Interactive comment on “Analysis of groundwater flow and stream depletion in the L-shaped fluvial aquifer” by Chao-Chih Lin et al.

D. Ferris david.ferris@usask.ca

Received and published: 15 December 2017

Figure 6: Temporal distributions of hydraulic head H_{i0} observed at piezometer O_i and H_{iF} simulated by the FEM simulations both reported in Kihm et al. (2007) and H_{iA} and H_{iM} predicted by the present solution and MODFLOW, respectively, for $i = 1 - 3$.

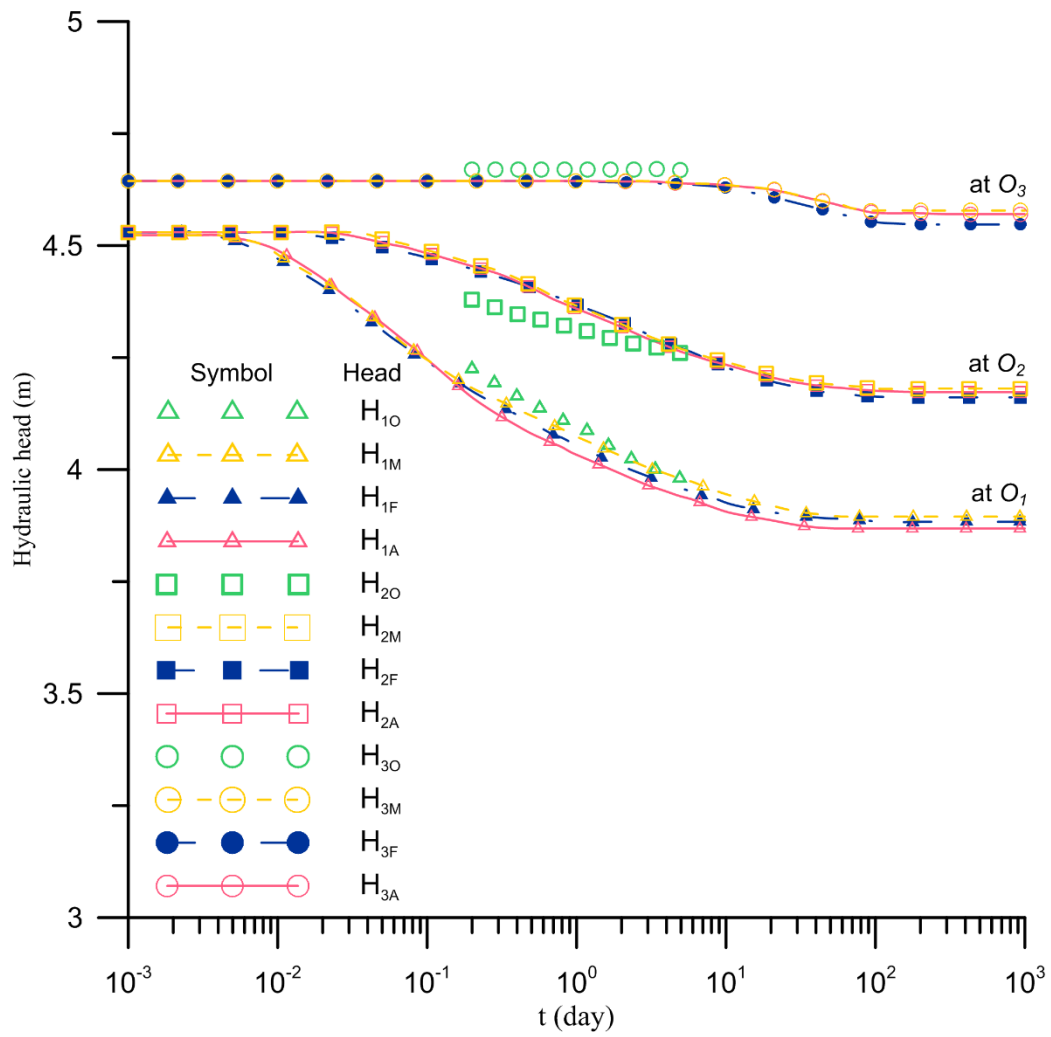
4. Figure 6 is an updated reprint of Kihm et al.’s Figure 12 (2007, P.12), but is not directly cited in the figure caption.

6. Although the piezometer data presented in Kihm et al. 2007 appears to support the modelled solutions, it should be noted that piezometer observations are only available over a period of 5 days; no information is presented to validate the modelled response to pumping beyond this period. Considering Figure 6, the 5-day observation period appears insufficient to observe any response to pumping at piezometer 3 (O3). This indicates that these data are irrelevant for the purpose of validating the transient solution for hydraulic head distribution presented by the authors.

Part of Figure 6 is from Kihm et al. (2007) (i.e. observation and FEM simulation at piezometers O_1 , O_2 and O_3) and therefore the citation of Kihm et al. (2007) has been added in the figure caption as

“Figure 6: Temporal distributions of hydraulic head H_{io} observed at piezometer O_i and H_{iF} simulated by the FEM simulations both reported in Kihm et al. (2007) and H_{iA} and H_{iM} predicted by the present solution and MODFLOW, respectively, for $i = 1 - 3$.”

In general, field observations for groundwater pumping are not easy to obtain and the measurement period is usually limited in a short time (Hunt et al., 2001; Fox, 2004; Lough and Hunt, 2006). We have compared the predicted results of proposed solution to the field data in a period of 5 days and the largest relative difference 1.74% occurs at O_2 . This result indicates that the present solution gives fairly good predictions in the early pumping period. In addition, the comparison of the temporal head distributions predicted by the present solution

“In addition, the largest relative differences between measured heads and predicted heads by the present solution at O_1 to O_3 during 0.1 to 5 day are respectively 1.64%, 1.74% and 0.62%, indicating that the present solution gives good predictions in the early pumping period.”
